STAFF REPORT
COMMUNITY DEVELOPMENT DEPARTMENT

HEARING DATE: 7/26/2022
 TO: Mayor & City Council
 FROM: Joe Dodson, Associate Planner
 208-884-5533
 SUBJECT: H-2022-0025
 Pickleball Court Subdivision
 LOCATION: Located at 4050 W. McMillan Road, at the northeast corner of N. Joy Street and W. McMillan Road, in the SE 1/4 of the SW 1/4 of Section 27, Township 4N, Range 1W.

Request for Annexation of 4.96 acres of land to be zoned from RUT in the County to the R-4 zoning district and a Preliminary Plat consisting of 14 single-family residential building lots and 4 common lots on 4.58 acres of land in the requested R-4 district, by The Land Group.

Preliminary Plat-Overview

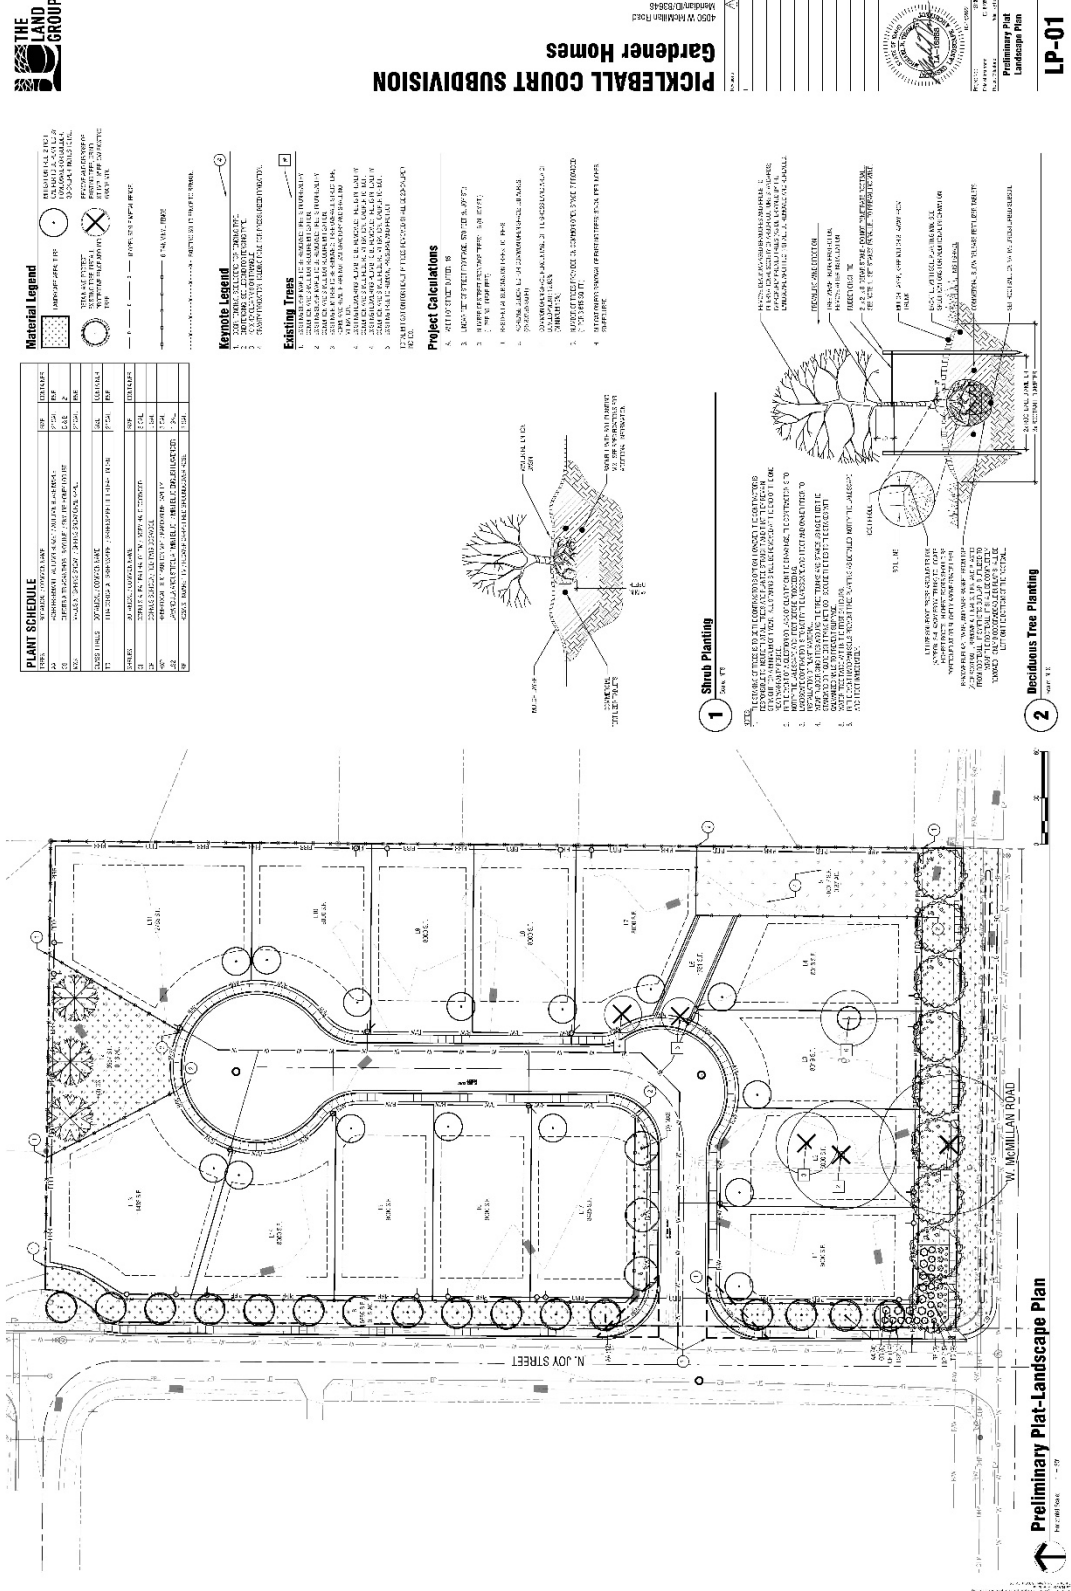
The residential lots are shown to meet all UDC dimensional standards per the submitted plat. In addition, all subdivision developments are also required to comply with Subdivision Design and Improvement Standards (UDC 11-6C-3). *Some of the lot dimensions shown on the submitted preliminary plat do not compute to the minimum lot size of 8,000 square feet. Prior to the City Council hearing, the Applicant should ensure all lots meet the minimum lot size requirement for the requested R-4 zoning district. Staff's calculations of the lot dimensions depicted show many of the lots are slightly under the minimum lot size—there are multiple areas in the subject site design where the needed extra area can be obtained by adjusting lot lines so Staff is not concerned with the Applicant being able to comply with this dimensional standard.*

Per UDC 11-6C-3B.4, no dead-end street shall be longer than 500 feet. The subject project is proposed with a cul-de-sac as the only access to the proposed single family lots and is shown to be approximately 450 feet in length and compliant with this code section. In addition, the Applicant is proposing one (1) common drive in the southeast corner of the project for access to Lot 4. Lot 7 also abuts this common drive but is not shown to take access from it as required by UDC 11-6C-3D.5. With the final plat submittal, the Applicant should provide an exhibit that demonstrates Lot 7 taking access from the common driveway in accord with UDC standards.

According to the submitted plat and landscape plan, the proposed 5-foot detached sidewalk along McMillan directly abuts the ultimate right-of-way line. UDC 11-3B-7C.1a requires that all detached sidewalks shall have an average minimum separation of greater than four (4) feet to back of curb to allow for vegetative separation between the travel lanes and pedestrian facilities and to ensure these facilities are in fact detached from the vehicular right-of-way. In these instances, "back of curb" is in reference to the ultimate right-of-way line. Therefore, the Applicant should submit revised plans depicting the detached sidewalk to be at least 4 feet behind the future right-of-way line.

2. The preliminary plat included in Section VII.B, dated March 18, 2022, shall be revised as follows prior to submitting for Final Plat approval:
 - a. Ensure all lots meet the minimum lot size requirement for the requested R-4 zoning district of 8,000 square feet.

- b. Any existing accesses to W. McMillan Road shall be closed upon development of the site.
 - c. Correct the plat to show Lot 7 to take access from the common drive, Lot 6 OR revise the plat to show Lot 4 with the minimum required street frontage of 30 feet when along a curve and remove the common drive altogether.

- d. Depict the required 5-foot wide detached sidewalk within the landscape buffer along W. McMillan Road and place it at least four (4) feet north of the ultimate right-of-way line to allow for landscaping on both sides of the sidewalk and ensure it is detached from the roadway and allow the 25-foot buffer to be measured from the ultimate right-of-way instead of the back of the sidewalk, per UDC 11-3B-7C.1a OR place said sidewalk within ACHD right-of-way per the ACHD condition of approval.

LP-01
 Preliminary Plat
 Landscape Plan

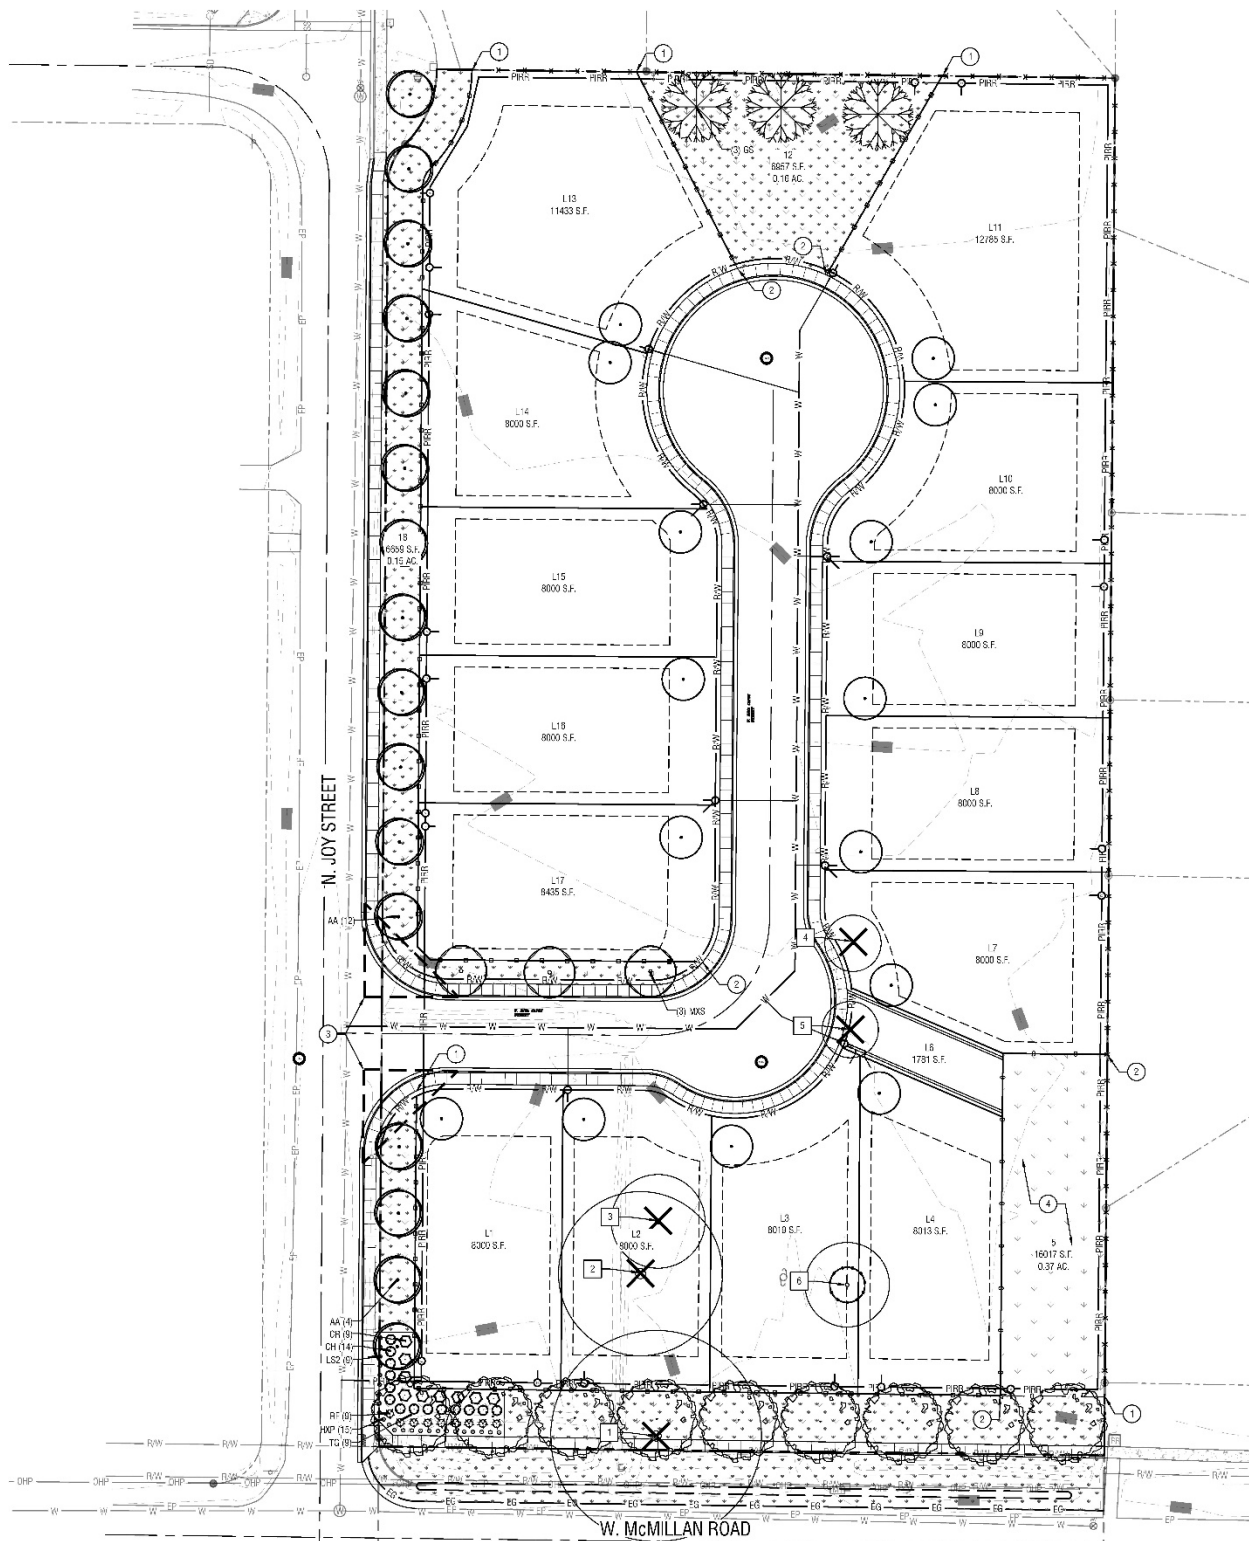
The Applicant is showing a common lot along W. McMillan Road that is at least 25-feet in width and is depicted with 9 trees and one landscape bed at the corner of Joy and McMillan; this proposed landscaping does not fully comply with UDC requirements. The number of trees shown complies with UDC requirements but UDC 11-3B-7 also requires vegetative ground cover beyond that of grasses. Specifically, no more than 65% of the landscaped area is permitted to be grass and other area shall be comprised of additional planting beds for shrubs and other vegetative ground cover. The Applicant should revise the landscape plan to depict additional vegetative ground cover to meet this standard.

The Applicant is showing approximately a 15-foot wide landscape buffer along the west boundary abutting the east side of N. Joy Street, measured from the back of sidewalk. This buffer is required to ensure the lots internal to the project do not have frontage to two public roads. City code requires these buffers to be a minimum of 10 feet in width so the Applicant's proposal to construct a 15-foot buffer exceeds code requirements. Essentially, the 15-foot buffer is a local street buffer that is still governed by code but is not typically required; the proposed site design has created this situation so landscaping standards apply. For example, a total of 14 trees are required within this buffer and the Applicant is showing 16 trees. However, UDC 11-3B-7C.3 requires that at least 25% of street buffer trees are Class II trees and it is not clear from the landscape table that the trees noted along Joy are Class I or Class II. The Applicant should clarify this and correct this if additional Class II trees are needed within this buffer.

There are two main areas of open space that would qualify under the UDC: 1) the required street buffer along McMillan, and 2) an open space lot along the north boundary of the project (Lot 12). In addition, the Applicant is showing an additional grassy area in the southeast corner of the site but this area is noted to be a future gravity irrigation holding pond. The submitted plans do not depict how this will be designed so Staff presumes it would not be qualified open space. The Applicant should add an exhibit and more detail to the landscape plan that shows how this "pond" will be constructed and what it will look like.

Within the Lot 12 open space lot along the north boundary, the preliminary plat has a notation that a pickleball court will be present. The Applicant should revise the landscape plans to depict this proposed amenity and its location. Staff is recommending a DA provisions requiring the applicant to comply with the open space and amenity as proposed.

3. The landscape plan included in Section VII.C, dated March 18, 2022, shall be revised as follows prior to submitting for Final Plat approval:
 - a. Depict the detached sidewalk along W. McMillan Road in accord with UDC 11-3B-7C.1a, as noted above.

- b. Depict the location of the noted ~~pickleball~~ sports court amenity within Lot 12 and provide a detail of the amenity.

- c. Depict the correct amount of vegetative ground cover per UDC 11-3B-7 in the landscape buffers along N. Joy Street and W. McMillan Road.
 - d. Clarify in the landscape calculations table the class type of the trees proposed and ensure the Joy Street buffer complies with UDC 11-3B-7C.3 that requires at least 25% of the required trees to be Class II.

- e. Include any and all tree mitigation information per UDC 11-3B-10 standards.
 - f. Add an exhibit and detail to the landscape plan that shows how the gravity irrigation holding pond (a portion of Lot 5) will be constructed and what it will look like, consistent with UDC 11-3G-3B.6 standards.
